Access Compliance Report

Public Rights-of-Way

(Curb Ramps)

Intersection ID: 2958	Main Street: CHINABERRY_CT	Cross Street: DOWNFIELD_WOOD_DR	Location: SE
ADA ID: 661646AEC8FE	Ramp Type: Perp	Initial Pass/Fail: Fail	Overall Compliance: No
Severity Score: 25			
Codes/Mitigation Info/Possible Solution		Field Measurements/Component Compliance

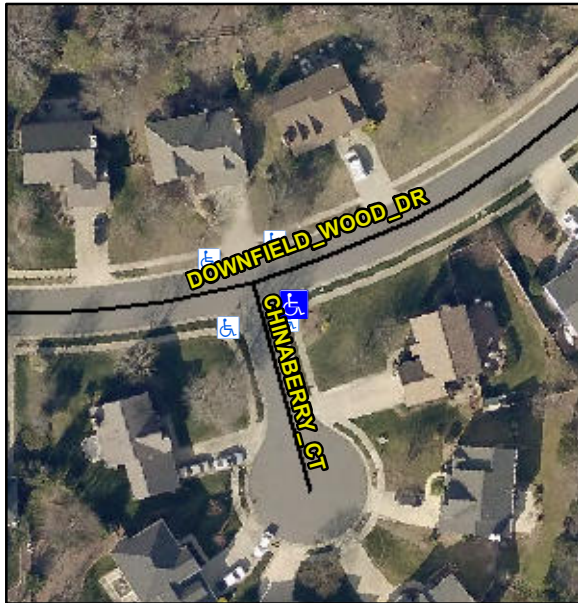
Not Found, R304.2.2

Compliance	Description	Data	Compliance	Description	Data
N/A	Ramp Length (in)	37.0	No	Ramp Slope (%)	12.2
Yes	Ramp Width (in)	48.0	Yes	Ramp XSlope (%)	1.5
N/A	Flare Type LT	N/A	N/A	Flare Type RT	N/A
N/A	Flare Slope LT (%)	N/A	N/A	Flare Slope RT (%)	N/A
N/A	Flare Traversable LT?	N/A	N/A	Flare Traversable RT?	N/A
N/A	Landing Length (in)	N/A	N/A	DWS Provided?	N/A
N/A	Landing Width (in)	N/A	N/A	DWS Contrast?	N/A
N/A	Landing Slope (%)	N/A	N/A	DWS Length (in)	N/A
N/A	Landing X Slope (%)	N/A	N/A	DWS Full Width?	N/A
N/A	Landing Curb? (Y/N)	N/A	N/A	DWS Offset (in)	N/A
N/A	Shared Landing?	N/A			
N/A	Gutter Ponding?	N/A	N/A	Gutter Slope (%)	N/A
N/A	Gutter Lip Ht (in)	N/A	N/A	Gutter X Slope (%)	N/A
N/A	Painted X Walk1?	No	N/A	Painted X Walk2?	N/A
	X Walk 1 Direction	To N		X Walk 2 Direction	N/A
N/A	X Walk 1 Width (in)	N/A	N/A	X Walk 2 Width (in)	N/A
	X Walk 1 Slope (%)	0.7		X Walk 2 Slope (%)	N/A
	X Walk 1 X Slope (%)	1.5		X Walk 2 X Slope (%)	N/A

Remove & Replace Entire Ramp.
